Office Action Summary	Application No. 10/527,374	Applicant(s) BECKMAN, JAMES R	
	Examiner ANTHONY SHUMATE	Art Unit 1797

DETAILED ACTION

6. Applicant's election of Group II, claims 12-20 drawn to a continuous contacting apparatus for exchanging heat released by a desiccant in the reply filed on 28 October 2008 is acknowledged. Because applicant did not distinctly and specifically point out the supposed errors in the restriction requirement, the election has been treated as an election without traverse (MPEP § 818.03(a)).

3 Sheets-Sheet 2

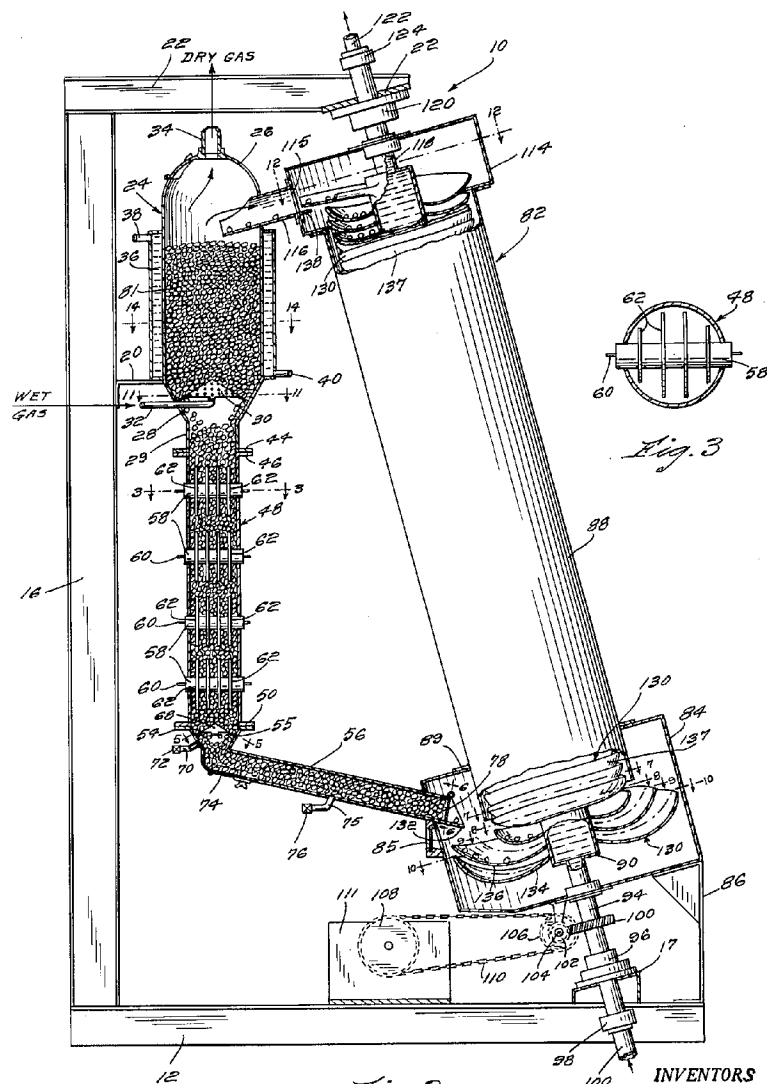
For instant **claim 12**, PAULSON et al. teaches at column 1 lines 1-70, column 3 lines 35-75, figure 2, and figure 3 a adsorption chamber (24) (heat-releasing chamber) having an inlet and an discharge (outlet) for a gas with moisture (at least partially saturated with a component absorbable by a

desiccant). Also, PAULSON et al. teaches at column 1 lines 1-70, column 3 lines 35-75, figure 2, and figure 3 the desiccant material thereby acting to absorb the moisture from the gas stream. Additionally, PAULSON et al. teaches at column 1 lines 1-70, column 3 lines 35-75, figure 2 and figure 3 the saturated gas to be conditioned is continuously circulated into the adsorption chamber (24).

Also for instant **claim 12**, PAULSON et al. teaches at column 1 lines 1-70, column 3 lines 35-75, column 4 lines 50-75, figure 2, and figure 3 a adsorption chamber (24) (heat-releasing chamber) having an inlet and an outlet for a desiccant.

Additionally for instant **claim 12**, PAULSON et al. does not specifically teach a annular water jacket 36 (heat-absorbing chamber) having an inlet and an outlet for a **gas** (fluid) to conduct away any heat generated (to be heated), but PAULSON et al. teaches at column 1 lines 1-70, column 3 lines 35-75, column 4 lines 50-75, figure 2 and figure 3 a annular water jacket 36 (heat-absorbing chamber) having an inlet and an outlet for **water** (fluid) to conduct away any heat generated (to be heated). Therefore, the jacket of PAULSON et al. is structurally capable of having an inlet and an outlet for a **gas**.

Also for instant **claim 12**, PAULSON et al. teaches at column 1 lines 1-70, column 3 lines 35-75, column 4 lines 50-75, figure 2 and figure 3 a substantial portion of the cylindrical part of the adsorption chamber (25) (common heat transfer wall) capable of conducting away any heat generated.

What's more for instant **claim 12**, PAULSON et al. teaches at column 1 lines 1-70, column 3 lines 35-75, column 4 lines 50-75, column 7 lines 25-65, figure 2 and figure 3 a reactivation chamber (48) (desiccant regenerator) having an inlet and an outlet, wherein the outlet provides a regenerated desiccant stream to the desiccant inlet (via transfer tube 116) of the adsorption chamber (24) (heat-releasing chamber).

Finally for instant **claim 12**, PAULSON et al. teaches at column 1 lines 1-70, column 3 lines 35-75, column 4 lines 50-75, column 7 lines 5-65, figure 2 and figure 3 wherein the inlet receives desiccant which as adsorbed moisture (spent desiccant stream) from the desiccant outlet of the adsorption chamber (24) (heat-releasing chamber).

For instant **claim 13**, PAULSON et al. teaches at column 1 lines 1-70, column 3 lines 35-75, column 4 lines 50-75, figure 2 and figure 3 wherein the desiccant inlet of the adsorption chamber (24) (heat-releasing chamber) is situated to place the desiccant onto the walls which conduct away any heat generated (i.e. heat-releasing side) of the substantial portion of the cylindrical part of the adsorption chamber (25) (common heat transfer wall).

For instant **claim 14**, PAULSON et al. teaches at column 1 lines 1-70, column 3 lines 35-75, column 4 lines 50-75, figure 2 and figure 3 an inlet and an outlet in the water jacket 36 (heat-absorbing chamber) for water (a liquid having a component evaporable into the gas). Also, the instant specification describes at page 12 lines 10-16 a liquid component evaporable into the air, such as feed **water**.

For instant **claim 15**, PAULSON et al. teaches at column 1 lines 1-70, column 3 lines 35-75, column 4 lines 50-75, figure 2 and figure 3 wherein the inlet for the water (the liquid having the evaporable component) is situated to place the water (liquid) onto the walls which conduct away any heat generated (heat-absorbing side) of the substantial portion of the cylindrical part of the adsorption chamber (25) (common heat transfer wall). Also, the instant specification describes at page 12 lines 10-16 a liquid component evaporable into the air, such as feed **water**.

For instant **claim 16**, PAULSON et al. teaches at column 1 lines 1-70, column 3 lines 35-75, column 4 lines 50-75, column 7 lines 5-65, figure 2 and figure 3 wherein the reactivation chamber (48) (desiccant regenerator) applies heat to the desiccant which as adsorbed moisture (spent desiccant stream) for regeneration.

Fig. 1.

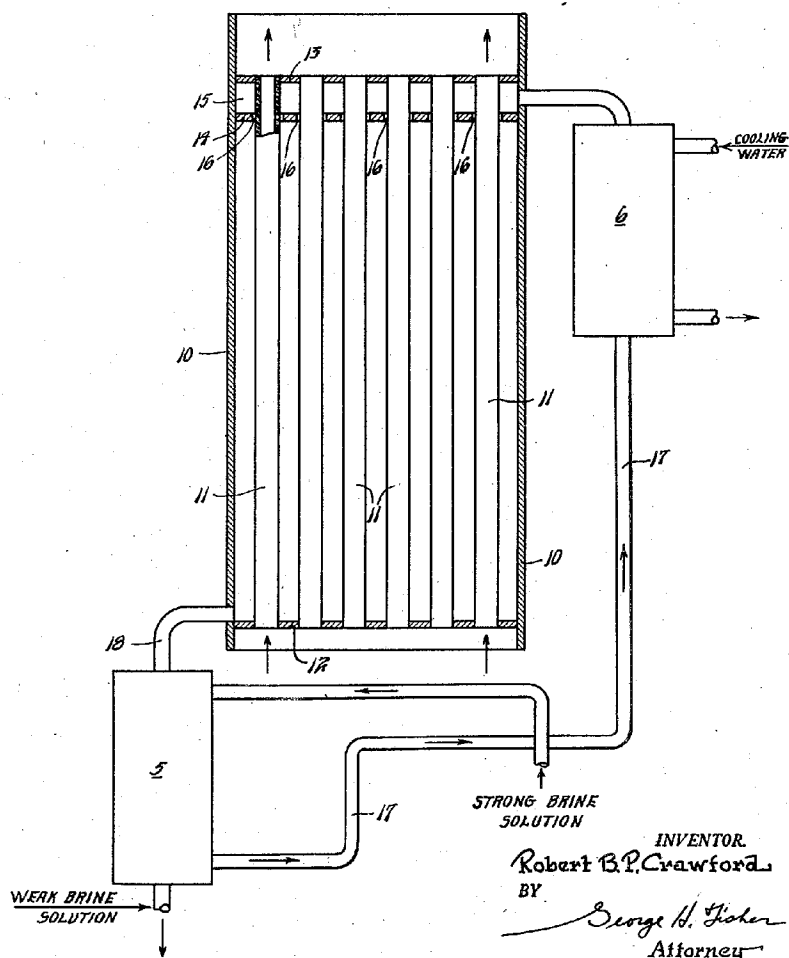
For instant **claim 12**, CRAWFORD teaches at column 1 lines 1-5, column 4 lines 20-50, figure 1 and figure 2 a dehumidifying chamber (20) (heat-releasing chamber) having an inlet (21) and an outlet (24) for air with water (a gas at least partially saturated with a component absorbable by a desiccant). Also, the instant specification describes at page 12 lines 10-16 a liquid component evaporable into the air, such as feed **water**.

Additionally for instant **claim 12**, CRAWFORD does not specifically teach a heat exchanger 6 (heat-absorbing chamber) having an inlet and an outlet for **gas** to cool the concentrated brine (i.e. fluid (**gas**) to be heated). But, CRAWFORD teaches at column 1 lines 1-5, column 4 lines 20-50, figure 1 and figure 2 a heat exchanger 6 (heat-absorbing chamber) having an inlet and an outlet for **water** to cool the concentrated brine (i.e. fluid (**water**) to be heated).

Additionally for instant **claim 12**, CRAWFORD teaches at column 1 lines 1-5, column 4 lines 20-50, figure 1 and figure 2 a pipe 17 (common heat transfer wall) where it is cooled (capable of providing thermal communication).

Furthermore for instant **claim 12**, CRAWFORD teaches at column 1 lines 1-5, column 4 lines 20-50, column 6 lines 35-65, figure 1 and figure 2 a brine concentrator chamber 45 (desiccant regenerator) having a brine spray 50 (an inlet) and an outlet (54).

As well for instant **claim 12**, CRAWFORD teaches at column 1 lines 1-5, column 4 lines 20-50, column 5 lines 15-30, column 6 lines 35-65, figure 1 and figure 2 wherein the brine concentrator chamber 45 (desiccant regenerator) outlet 54 provides a concentrated brine (regenerated desiccant) stream to the

Moreover for instant **claim 12**, CRAWFORD teaches at column 1 lines 1-5, column 4 lines 20-50, column 5 lines 15-30, column 6 lines 35-65, figure 1 and figure 2 wherein the brine concentrator chamber 45 (desiccant regenerator) having a spray 50 (an inlet) receives weak brine solution (spent desiccant stream) from the sump 30 (desiccant outlet) of the dehumidifying chamber 20 (heat-releasing chamber).

For instant **claim 18**, CRAWFORD teaches at column 1 lines 1-5, column 4 lines 20-50, column 5 lines 15-30, column 6 lines 35-65, column 7 lines 1-30, figure 1 and figure 2 wherein the brine concentrator chamber 45 (desiccant regenerator) contacts the weak brine (spent desiccant) with outside (ambient) air for concentrating (regeneration).

For instant **claim 19**, CRAWFORD teaches at column 1 lines 1-5, column 4 lines 5-50, column 5 lines 15-30, column 6 lines 35-65, column 7 lines 1-30, figure 1 and figure 2 a heat exchanger 5 situated between the chamber 10 (similarly chamber 45) (heat releasing chamber) and the brine concentrator (desiccant regenerator), and the heat exchanger 5 where heat is given up by the hot concentrated brine in pipe 17 to the cooler weakened brine in pipe 18 (transferring heat from the spent desiccant stream (weakened brine) to the regenerated desiccant stream (concentrated brine)).
